**Re: FINAL SAMPLING AND ANALYSIS PLAN ADDITIONAL INVESTIGATION AT  
SITE 22- SOUTHWEST FENCE LINE AND SEAL CREEK, NAVAL WEAPONS  
STATION SEAL BEACH, DETACHMENT CONCORD, CONCORD,  
CALIFORNIA**

**Final**

## **Sampling and Analysis Plan**

# **Additional Investigation at Site 22 – Southwest Fence Line and Seal Creek**

**FIGURE 7**  
**PROPOSED SEDIMENT SAMPLING**  
**LOCATIONS IN MOUNT DIABLO / SEAL CREEK**  
**AND SITE 22**

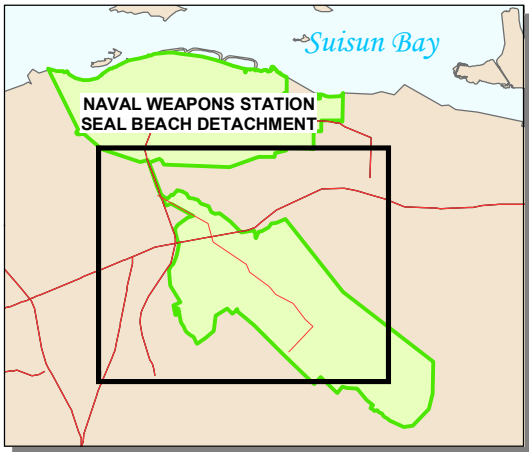
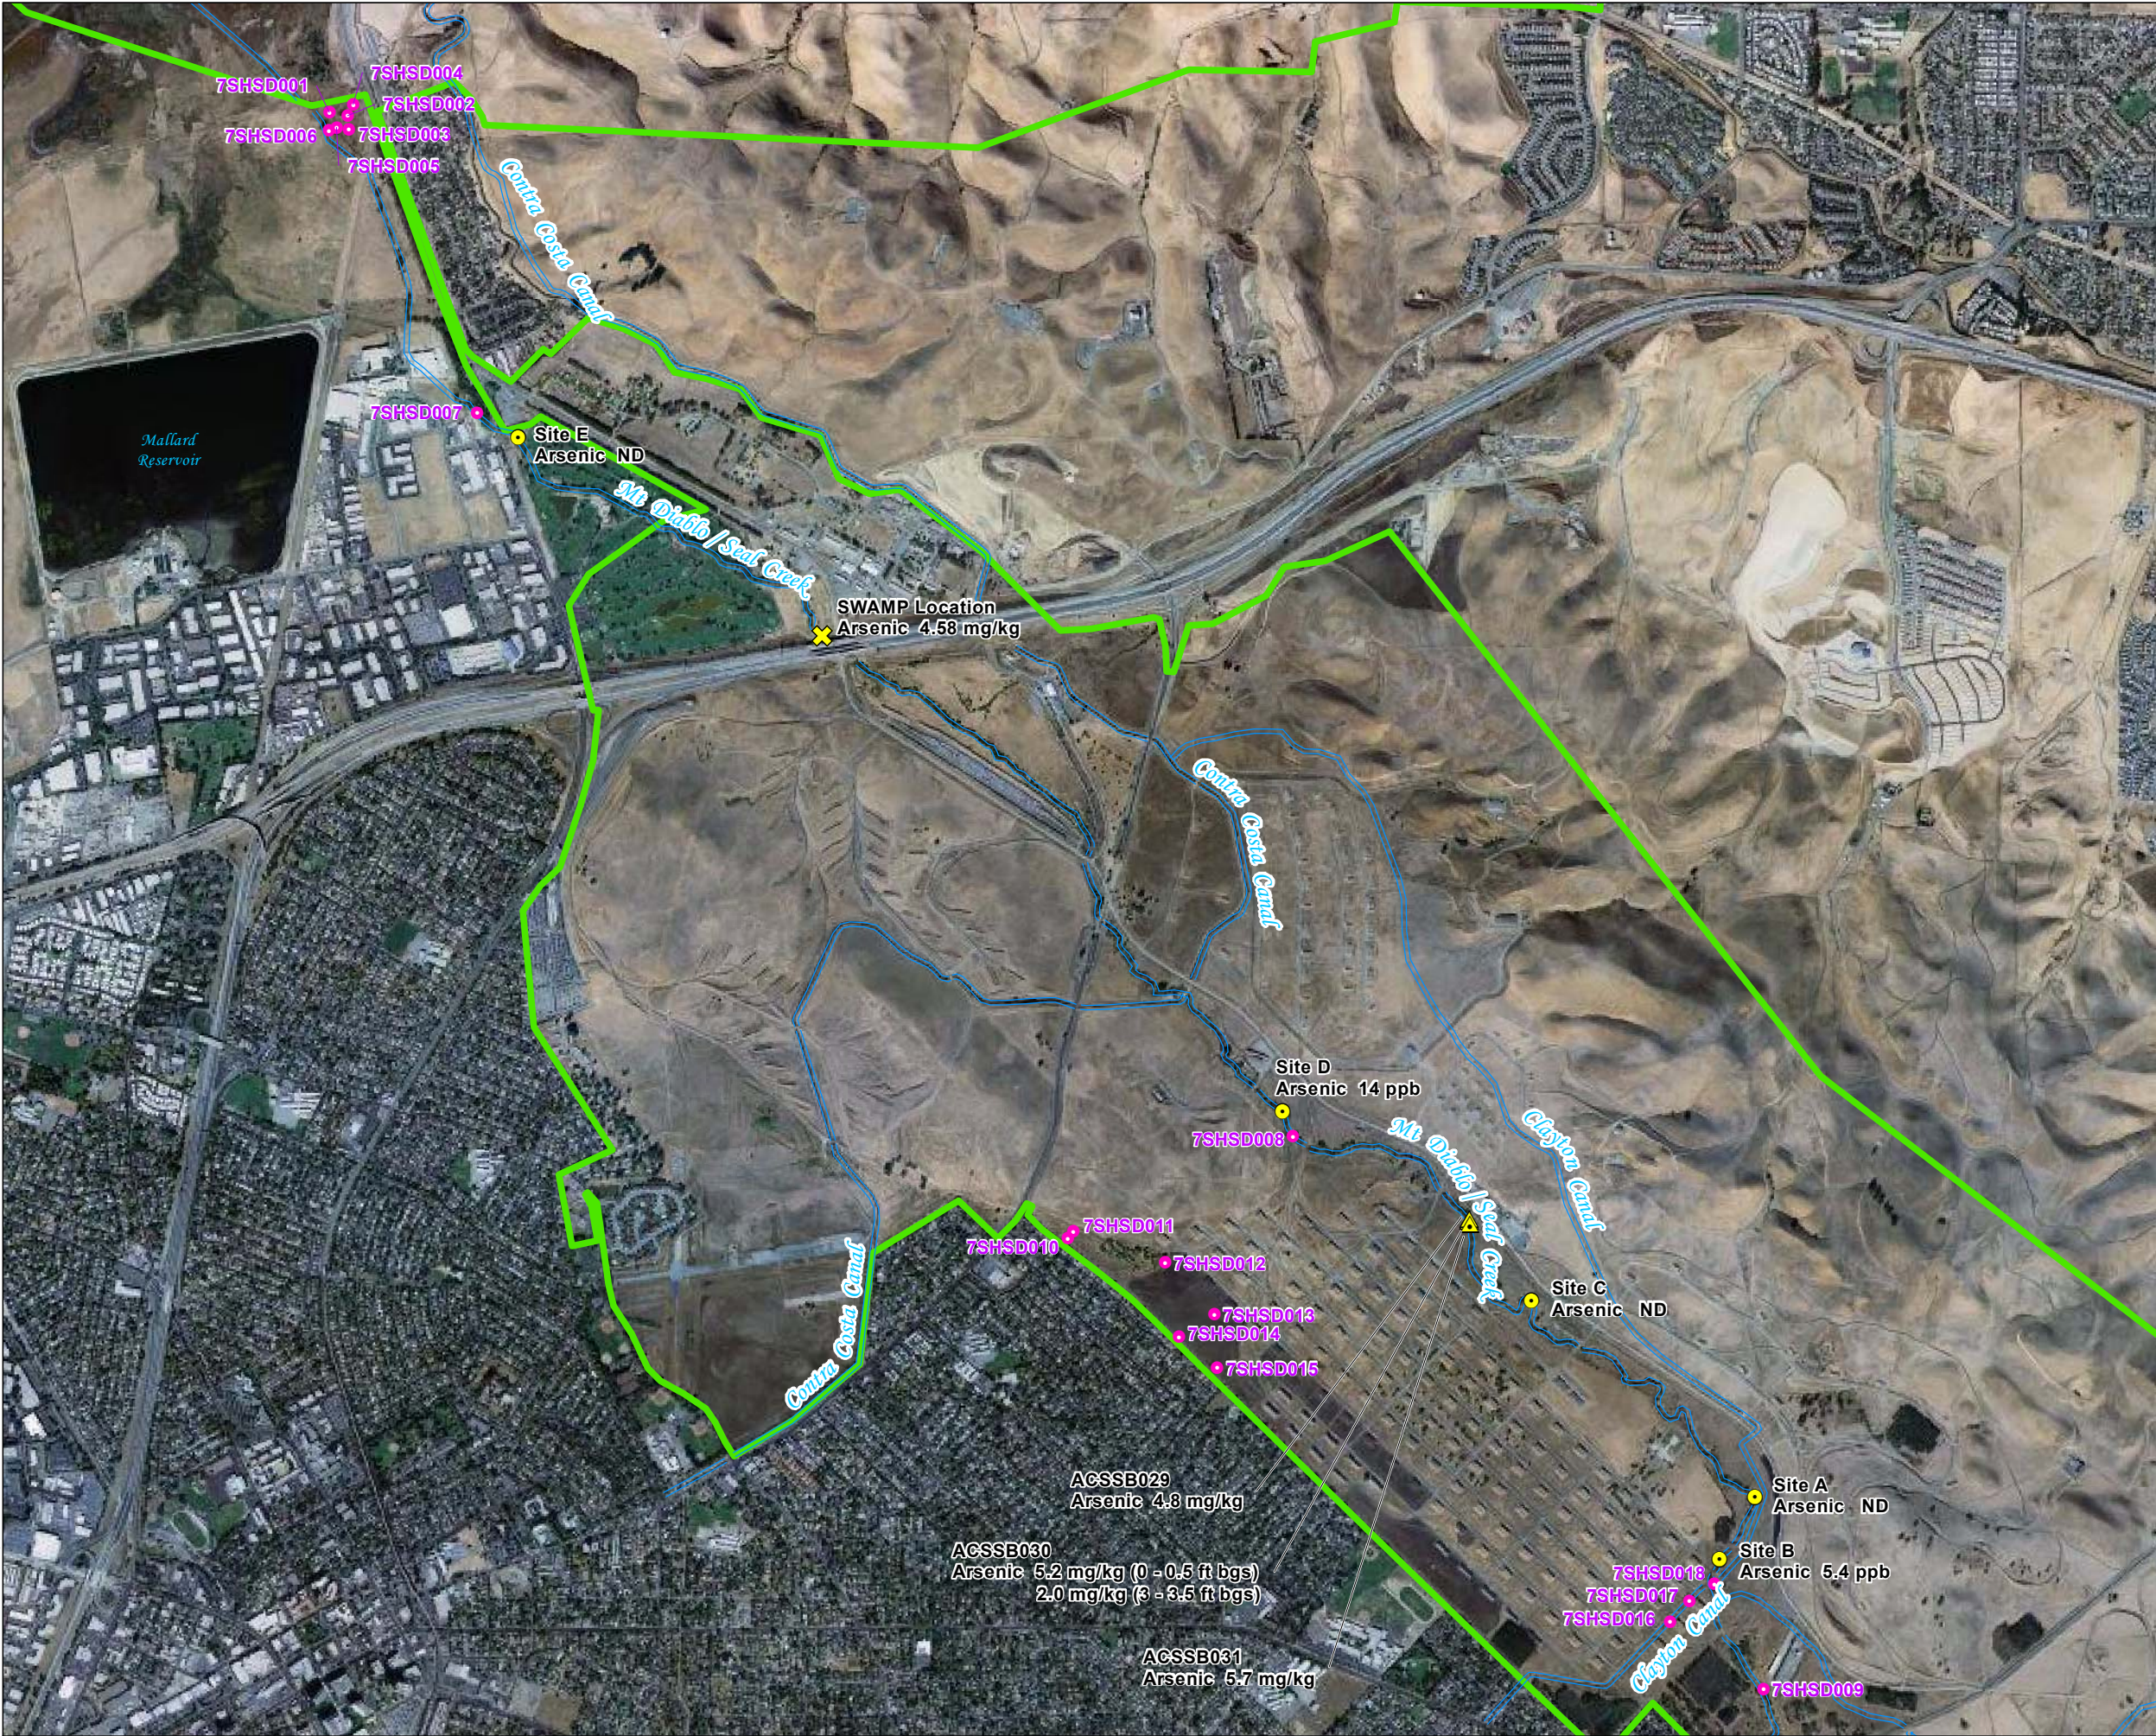
6. **Comment:** Section 1.2.1, Project Objectives (Mount Diablo Creek Assessment); and Figure 7, Proposed Sediment Sampling Locations in Mount Diablo/Seal Creek: As indicated above in General Comment number 2, U.S. EPA requests that the Navy include two additional sampling locations (for replicate sampling) along the creek within the facility boundary. The down-stream sampling location (7SH5D004) while close to the area walked by the Navy and regulators several months ago, may not be located in the area of the creek where sedimentation is occurring. This furthest down-stream sampling location was to assess contaminant concentrations in sediment transported from the upper reaches and the Navy will need to document, that the location it selected is the terminal end of the creek (likely where creek surface flows intersect tidally influenced marsh surface water). This sampling site should be cited primarily based on the physical site conditions and not site access. U.S. EPA also encourages the Navy to contact the property owner(s) and secure sampling access for the down-stream sampling location as soon as possible.

7. **Comment:** Section 1.2.1 and Figure 7 (Mount Diablo Creek Assessment): U.S. EPA support California Fish and Games July 1, 2005, general comment number 3 and reference to a previous February 23, 2005, memorandum on Solid Waste Management Units (SWMUs) Feasibility Study that recommended further characterization of Mount Diablo Creek to address potential contamination from the SWMUs sites. U.S. EPA supports Fish and Game's recommendations to analyze sediment samples from the creek near the SWMUs sites (sampling location 7SH5D003 and 7SH5D004) for metals, pesticides and total petroleum hydrocarbons (TPH).

8. **Comment:** Section 1.2.1, and Figure 7 (Mount Diablo Creek Assessment): U.S. EPA understands that the Regional Water Quality Control Board may still have outstanding sampling requirements associated with a steam cleaning discharge pipe at Site 17, where the U.S. EPA is currently reviewing the Navy's Final No-Action Record of Decision (ROD). While Program staff have been supportive of the Navy's no-action decision and ROD, we believe the Navy could utilize the Site 22 Sampling Plan to document the collection of additional sediment data at the steam cleaning discharge pipe to cost effectively address a Site 17 characterization issue identified by the Regional Board. The Site 17 steam cleaning discharge pipe at Mount Diablo Creek represents a suitable location for one of the two additional sampling locations requested by U.S. EPA above in Specific Comment number 6.

5. **Comment:** Page 12, Figure 7 (Proposed Sediment Sampling Location). We believe that this accurately indicates the proposed sampling locations.

**Response:** *The sampling points near the terminus of Mount Diablo/Seal Creek were revised during the site visit on September 23, 2005, as shown on [Figure 7](#).*

*As identified during the September 23, 2005, site visit, the Navy will collect three sediment/soil samples from within the abandoned Clayton Canal ([Figure 7](#)).*

- Response:** [Figure 7](#) has been revised to include the sample locations and analytical results from samples collected within Seal Creek as part of the Site 17 Investigation and Surface Water Ambient Monitoring Program.

**Response:** The analytical data for the Water Board's surface water samples have been added to [Figure 7](#).
